RE: NEWCASTLE GAS STORAGE FACILITY (10-0133)

Review of AGL Gas Liquefaction Plant Environmental Assessment (EA)

**AGL ENERGY LIMITED
NEWCASTLE GAS STORAGE FACILITY
REVISED SITE STORMWATER MANAGEMENT PHILOSOPHY**

FIGURE 1
SKETCH CI-0002

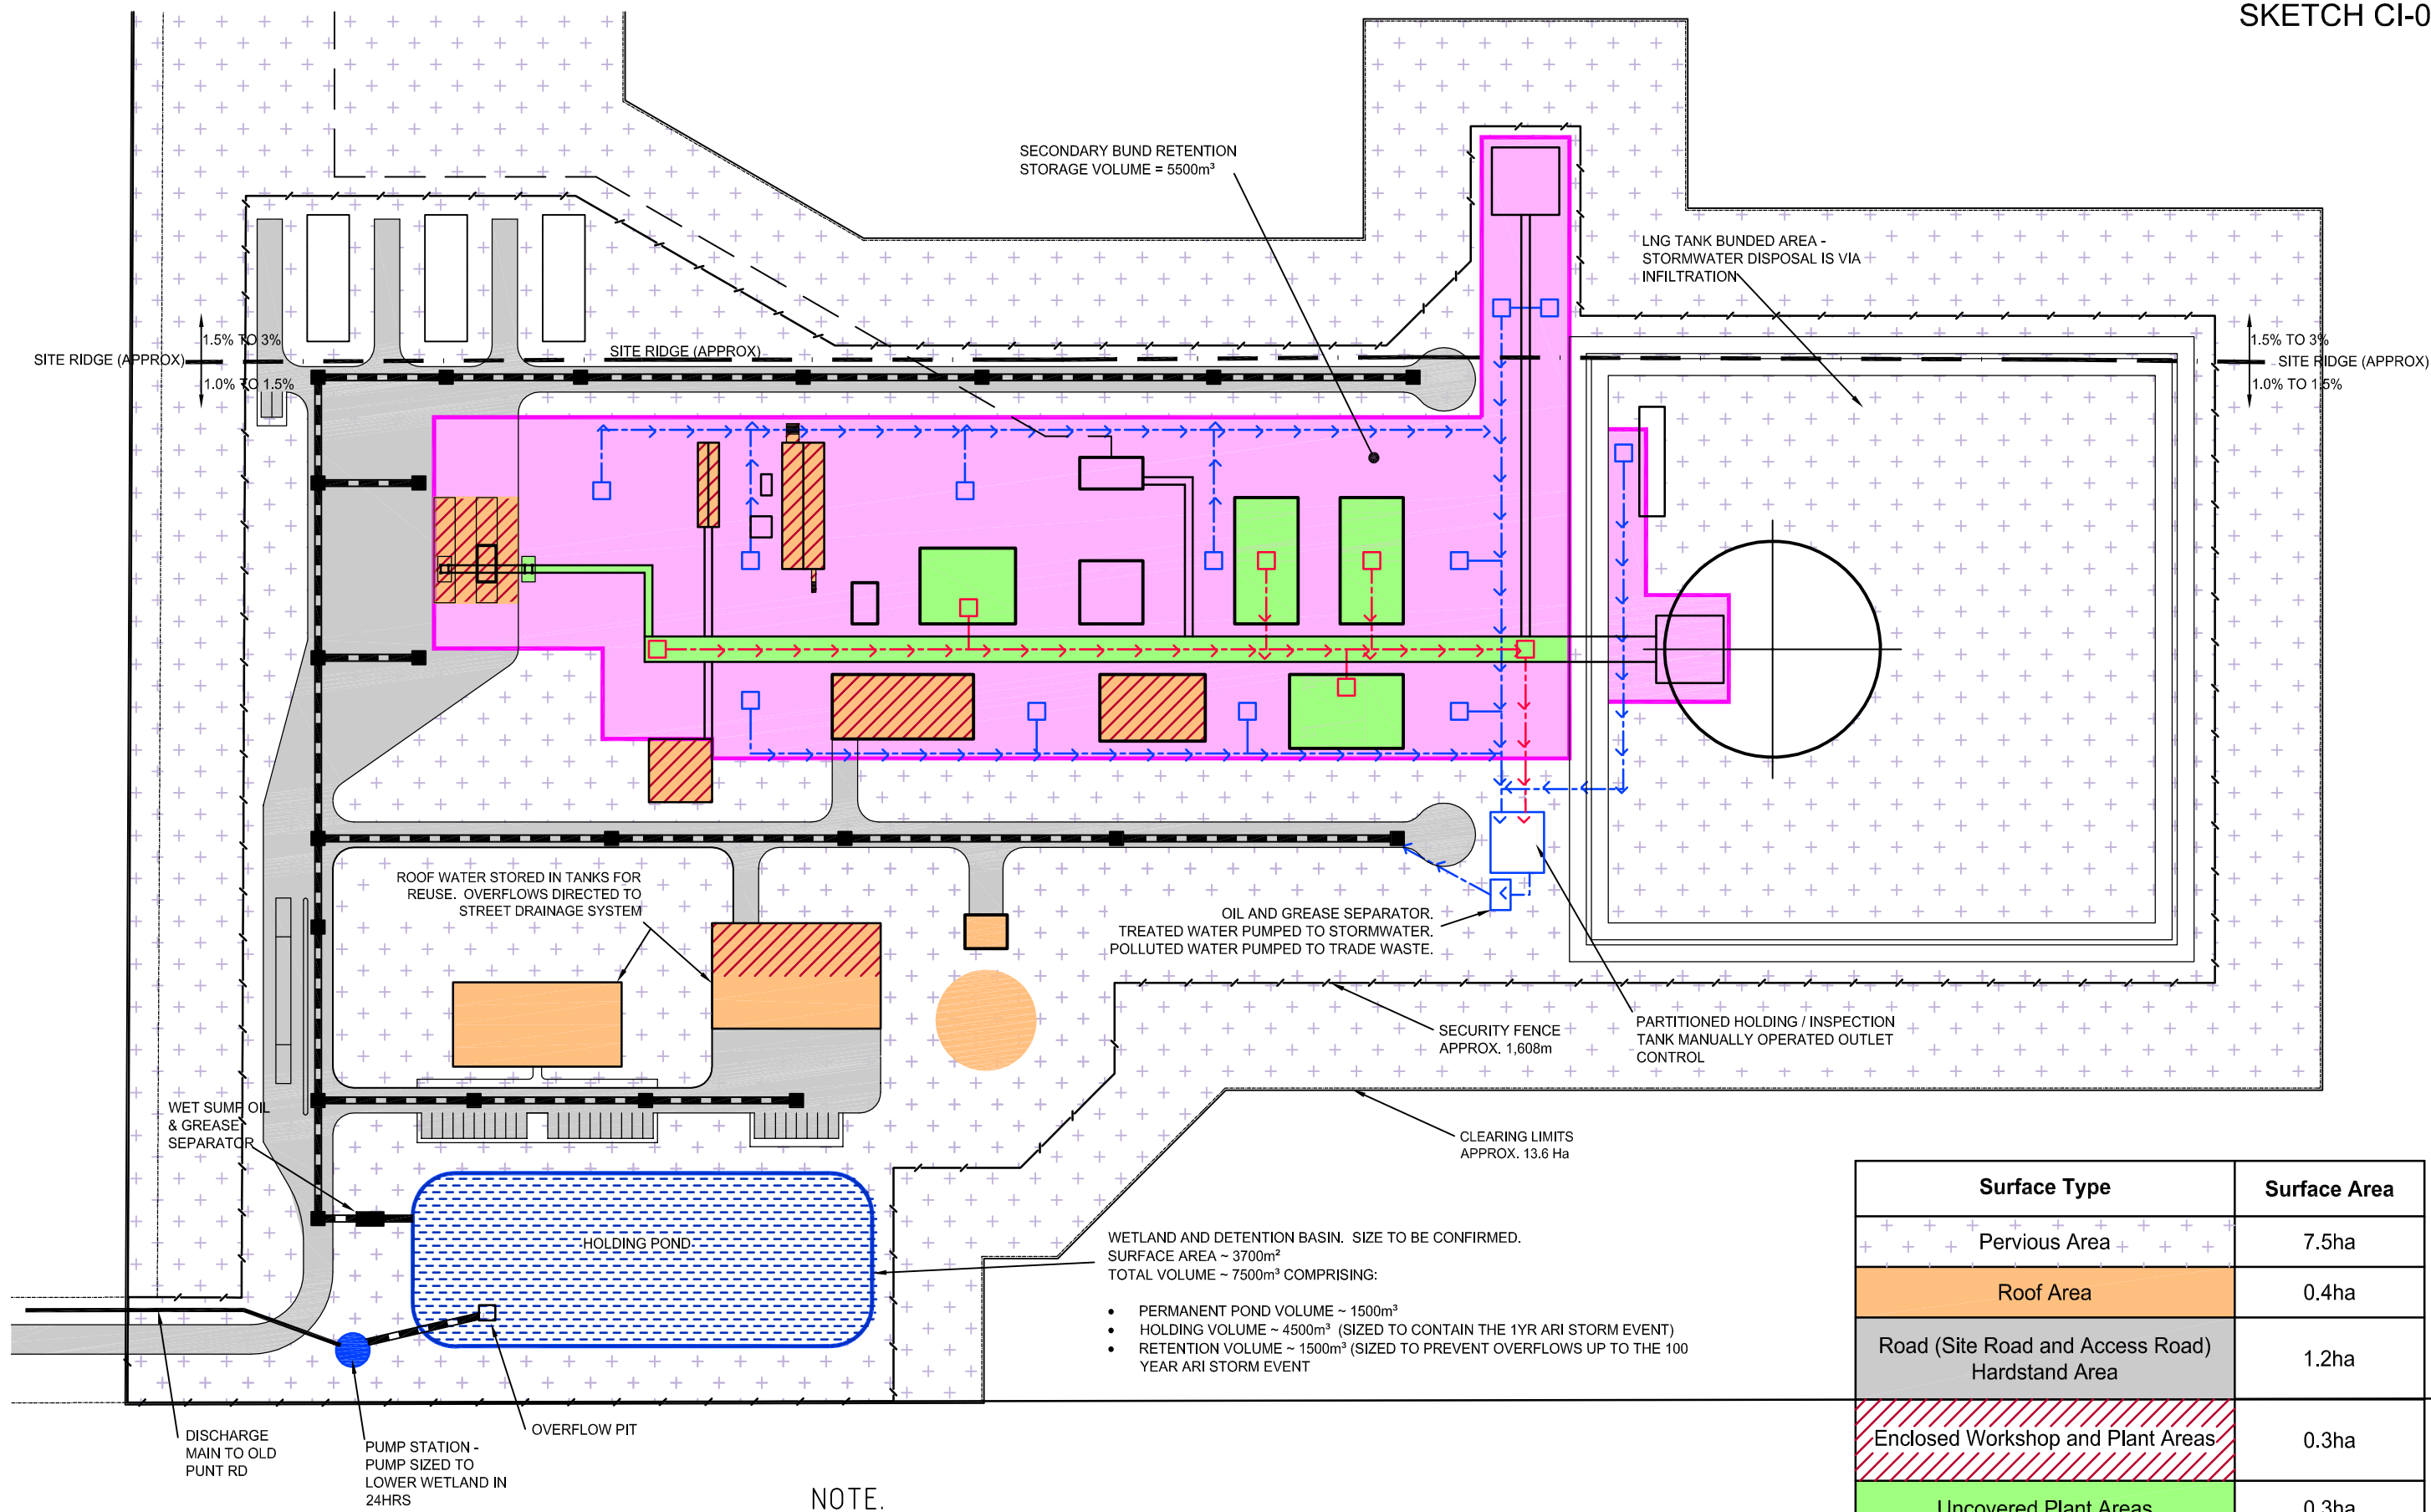
Hunter Water has reviewed the stormwater management plan that is contained in the EA and as modified in the correspondence attached in Appendix A to this submission. The proposed strategy has been designed to provide separation of stormwater that is generated off roadways within the fenced area of the site, the uncovered plant areas, and the general plant areas from the aquifer beneath the site. Stormwater will be collected in a holding pond, and then discharged off the site into a creek line that flows west towards the Hunter River. The system is designed for up to a 1 in 100 year ARI rain event. It is extremely important that the detail design, selected materials and workmanship are of a sufficient standard to ensure that the proposed system will be built water-tight and have a design life that is commensurate with the design life of the facility as a whole.

Within the fenced complex, the proposed strategy will not catch stormwater from non-plant areas, and will not catch stormwater from the LNG tank bunded area. While it is not inconceivable that pollution could enter the aquifer from these areas, the risk of pollution from these areas is low and can be managed. It is proposed in the EA, in Chapter 4.2, that access to the site will require entry through a security gatehouse and that the site will be manned and monitored by security personnel 24/7. Such security will substantially mitigate the risk of unauthorised activities occurring on the site that may pose a risk to the aquifer. With regard to the bunded tank area, LNG itself, while being a highly hazardous material from many perspectives, cannot cause pollution of the groundwater beneath the site. In order to perform its required purpose, the bunded tank area will effectively be sterilised from other activities apart from site maintenance.

The proposed stormwater management strategy does not extend outside the fenced complex. Arguably the greatest risk to the aquifer in these areas would be third party illegal dumping of toxic materials, which would be possible in the cleared area surrounding the security fence, along the utility corridor, and especially along the main access road. Hunter Water is of the opinion that this risk has not yet been adequately addressed.

- The site grading has been modified so that the majority of the site drains to the south-western corner of the site. The exceptions to this are the LNG Tank on the eastern side of the site (approx 1.6Ha) and the switch yard on the northern side of the site (approx 0.2Ha). Both these areas are considered low pollutant risks and will be bunded in accordance with the relevant Australian Standards.

- Enclosed workshops will be drained directly to the trade waste system.
- Plant areas (approx 2.3Ha) will be bunded to contain the 20 year ARI 24 hour storm event and comply with the relevant Australian Standards. Runoff from this area will be captured at an inspection tank where it will be manually tested prior to release. In the event it is polluted the water will be pumped to the trade waste system for disposal. Where the water quality is satisfactory, the water will be pumped to the stormwater system. It is likely that the plant area will be divided into smaller areas based on risk to minimise the volumes of polluted water being disposed of via trade waste. A preliminary division is shown in the attached figures as “General Plant Areas” and “Uncovered Plant Areas”.

- Runoff from the sites impervious areas will be directed via a piped drainage system to a wet sump GPT and then wetland/holding pond (excluding the LNG Tank, electrical switchyard and pervious areas outside of operational zones). Surface flows up to the 100 year ARI storm event will also be directed to the wetland. The wetland/holding pond comprises three zones as follows:

1. **Wetland Zone** - this will be sized to achieve the water quality objectives of Port Stephens Council's “Urban Stormwater and Rural Water Quality Management Plan for New Developments”. Based on the current layout a permanent wetland volume in the order of 1500m³ is anticipated.

2. **Holding Zone** – an additional holding volume is provided to contain runoff from the catchment up to the 1 year ARI 24 hour duration storm event. Based on the current layout a holding volume of approximately 4500m³ is anticipated. Water quality will be inspected and, if satisfactory, discharged from site via a pump station. If the water quality is unsatisfactory, the water will either be disposed via the trade waste system, or treated prior to being discharged from site via a pump station.

3. **Retention Zone** – A further volume will be provided to prevent overflows up to the 100 year ARI 72 hour duration storm event. If the water level rises to this zone, the pump station will switch on automatically and discharge water from the site. A pump flow rate of about 75L/s is anticipated, as this is between the 1 year and 2 year ARI for the site, but is subject to approval from Council. Based on this an additional active storage volume of 1500m³ is required.
